JUNIPER 9-322
ENERGY STAR

PROJECT NAME
LECCO RIDGE

SHEET TITLE AREA CHARTS	
SCALE 3/16"=1'-0"	BY ZMP
DATE APR 2017	TYPE

TOWN OF MILTON
PLANNING AND DEVELOPMENT
BUILDING PERMIT: 17-7104
BUILDING: REVIEWED
SCOTT SHERRIFFS JUN 13, 2017
PLANS EXAMINER DATE
Neither the issuance of a permit nor carrying out of inspections by the Town of Milton relieves the owner from full responsibility for compliance with the provisions of the Ontario Building Code Act and the Ontario Building Code, both as amended, as well as other applicable statutes and regulations of the Province of Ontario, By-laws of the Region of Halton and Town of Milton

REAR ELEVATION 3

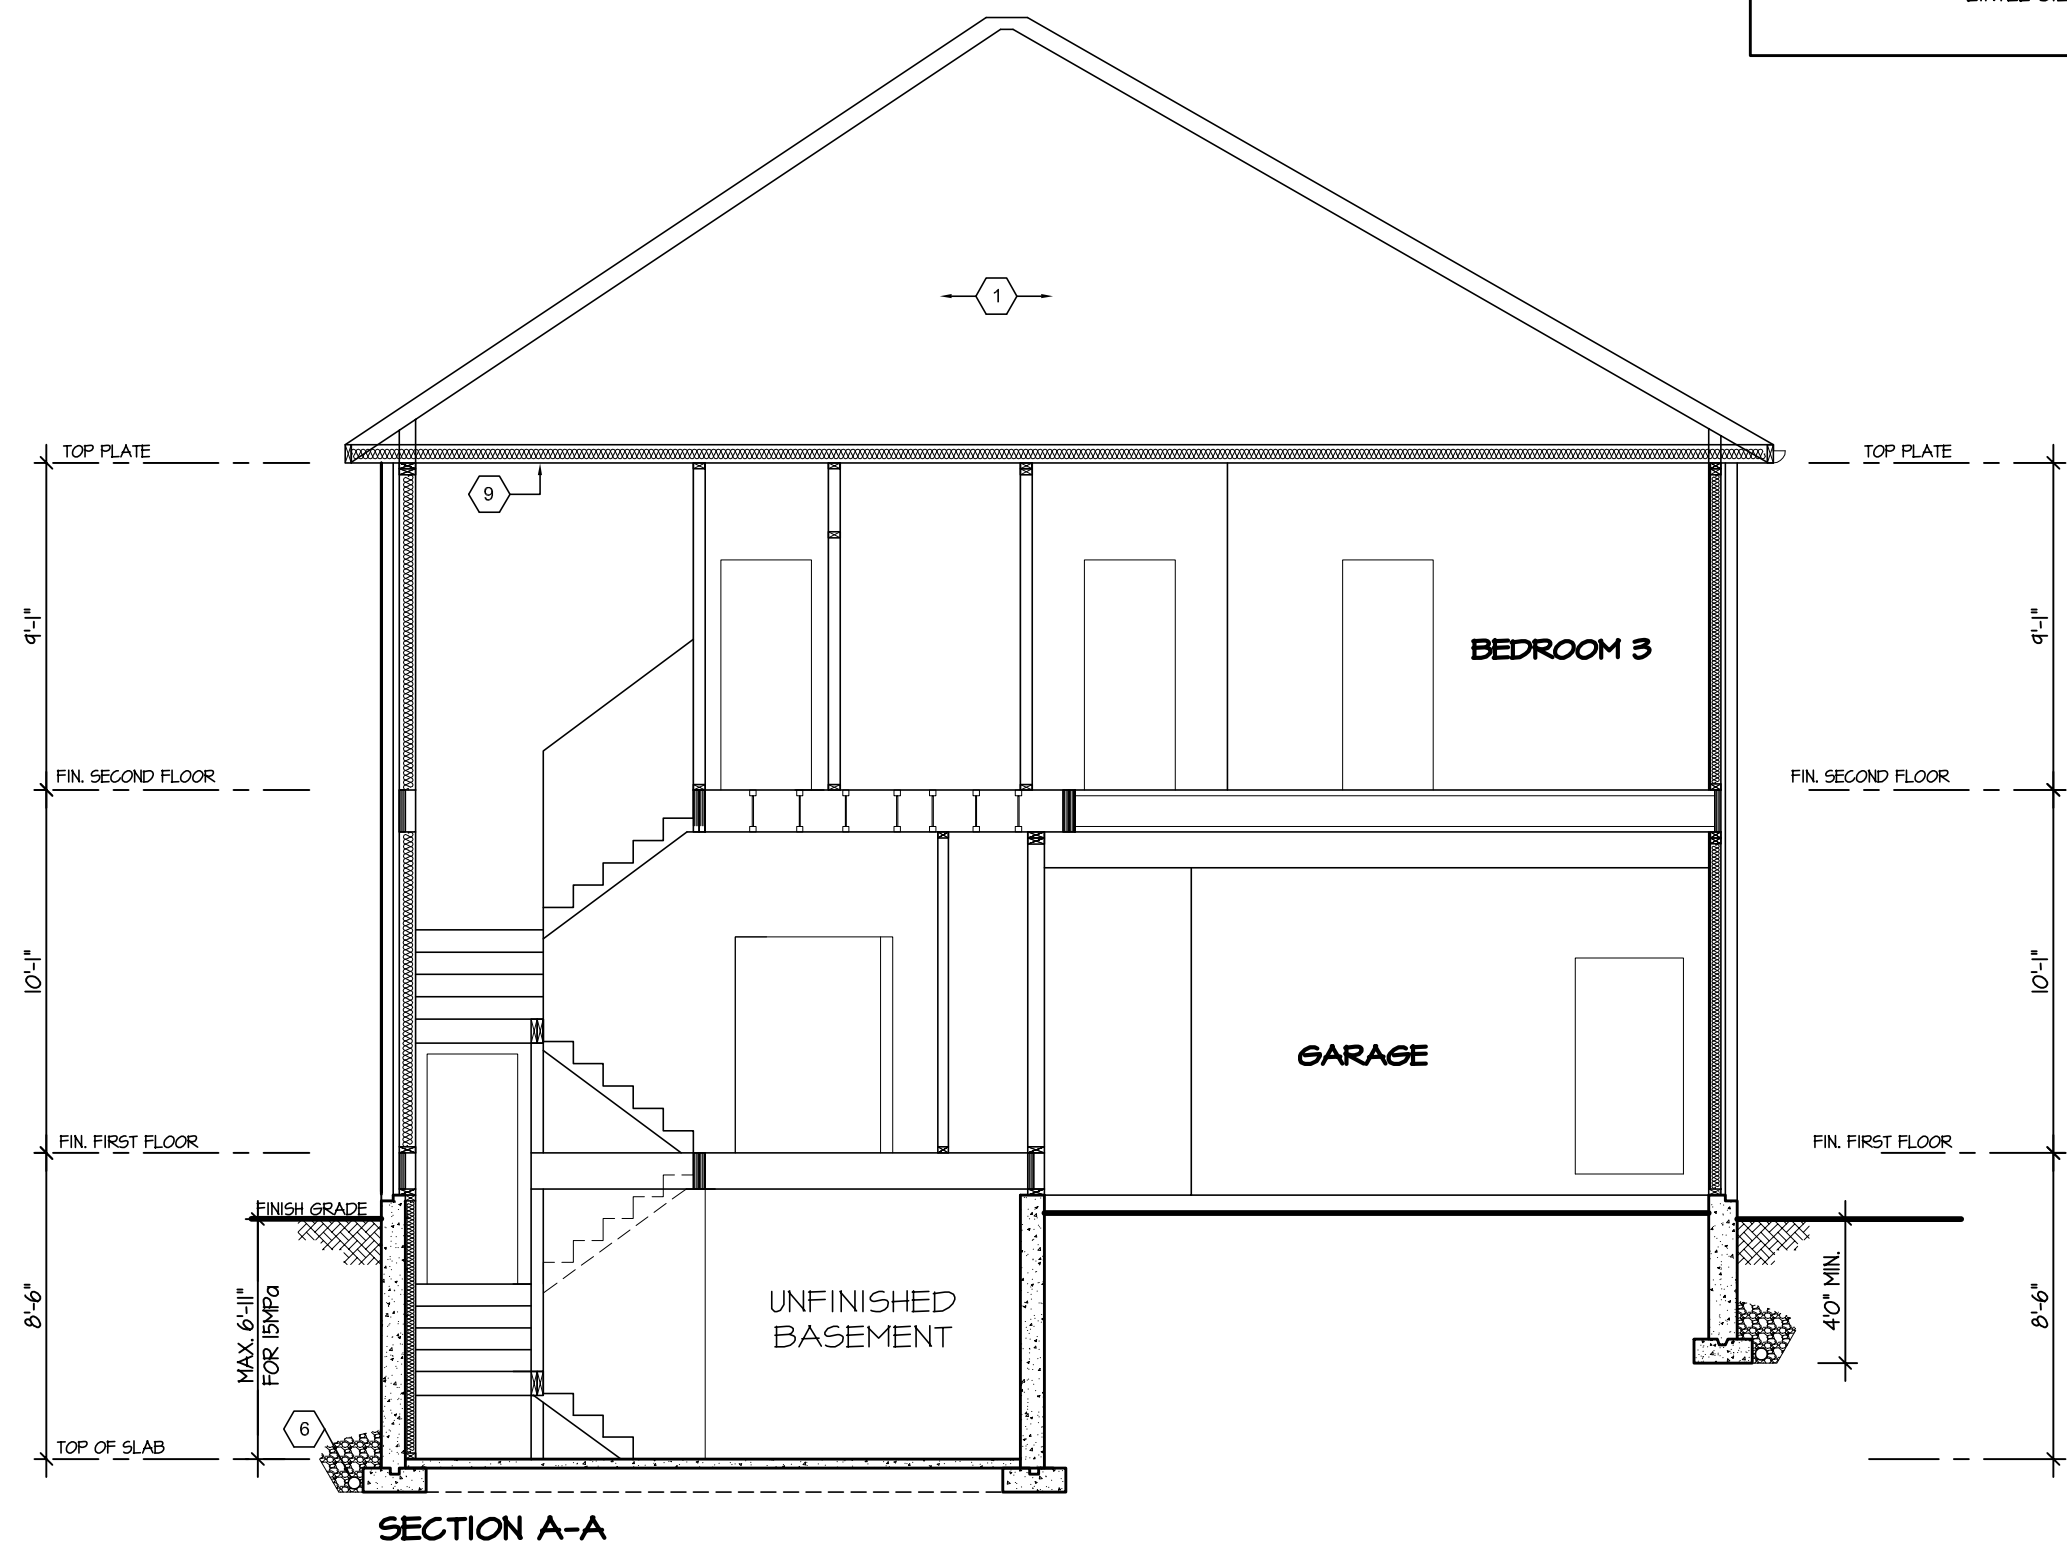
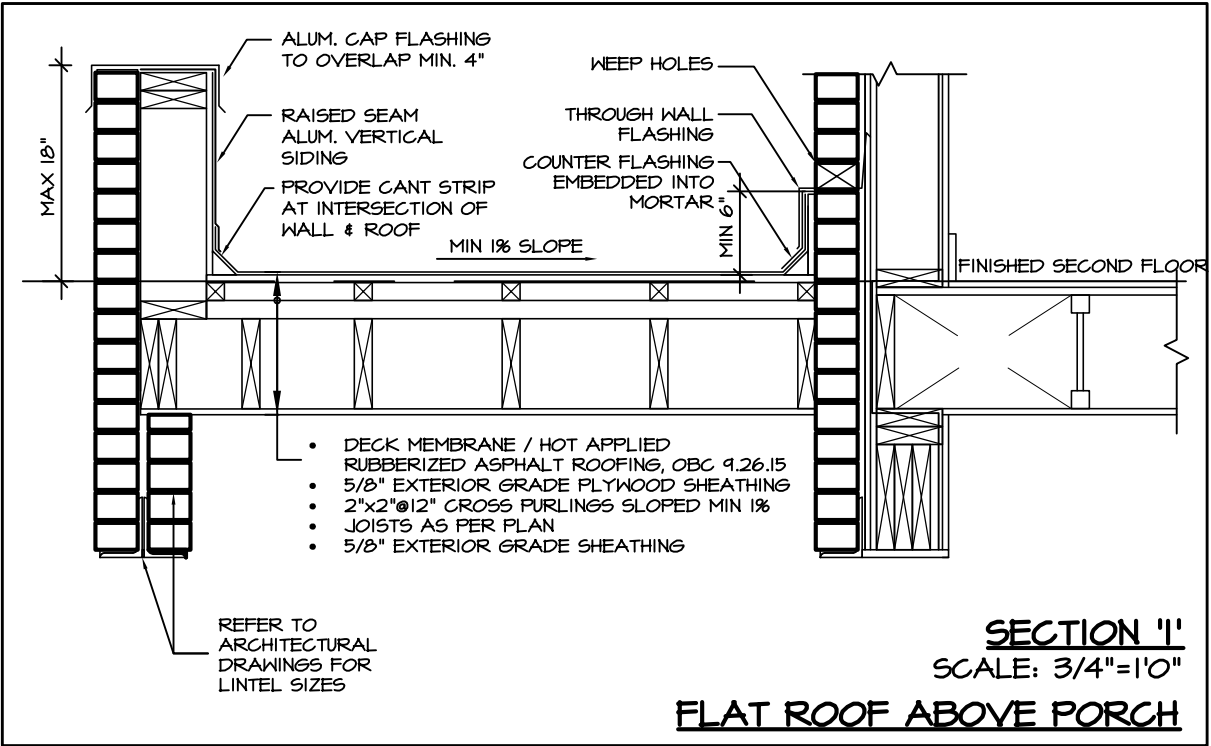
DECK DETAILS
See standard details pages 5
and 5-2 for additional deck
construction details
